30 Mactier Street, Narrabeen

Geotechnical Comments for New DA.

PRELIMINARY GEOTECHNICAL ASSESSMENT:

Preliminary Assessment Flow Chart – Northern Beaches Council (Warringah)

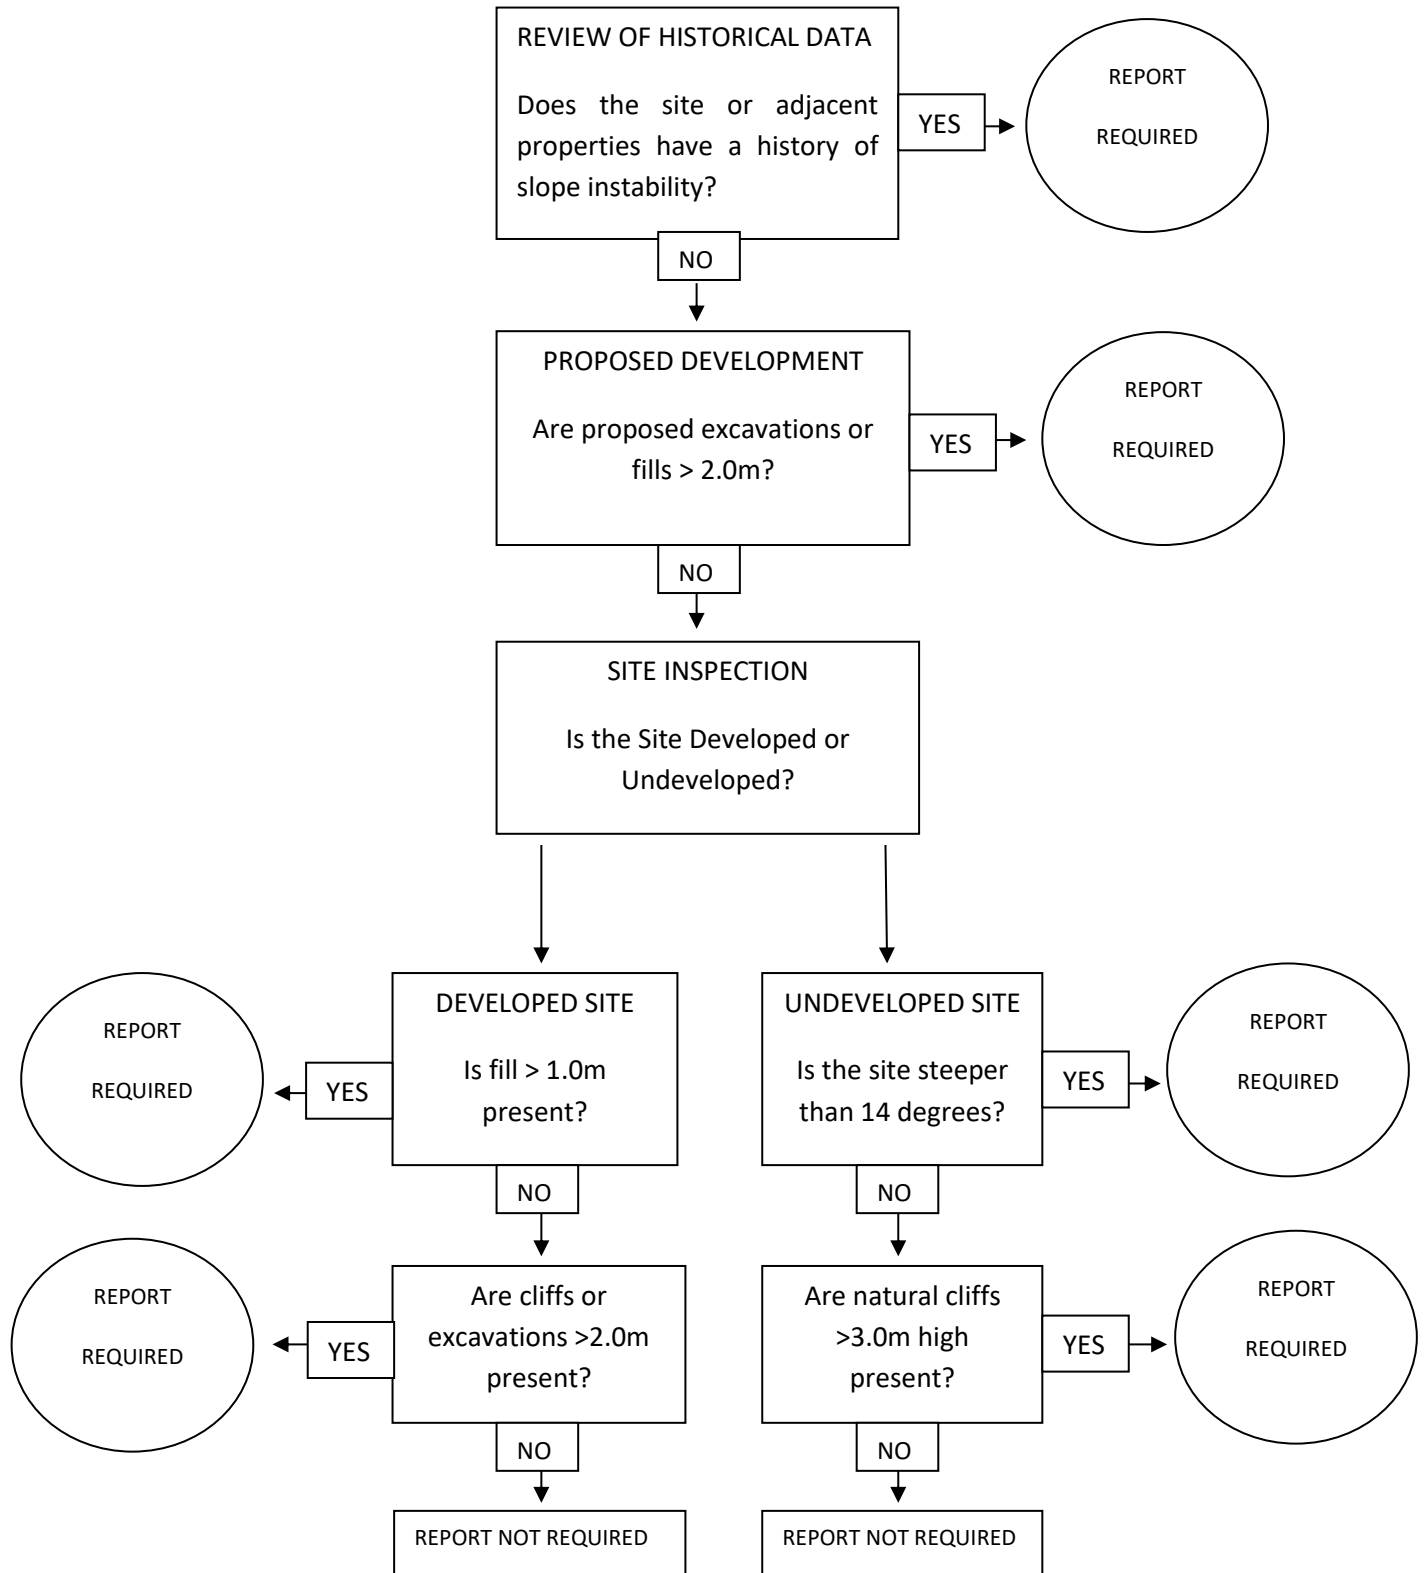
The proposed development and site conditions were considered and applied to the Council Flow Chart.

Provided good engineering and building practice are followed, no further Geotechnical assessment is recommended for the proposed development.
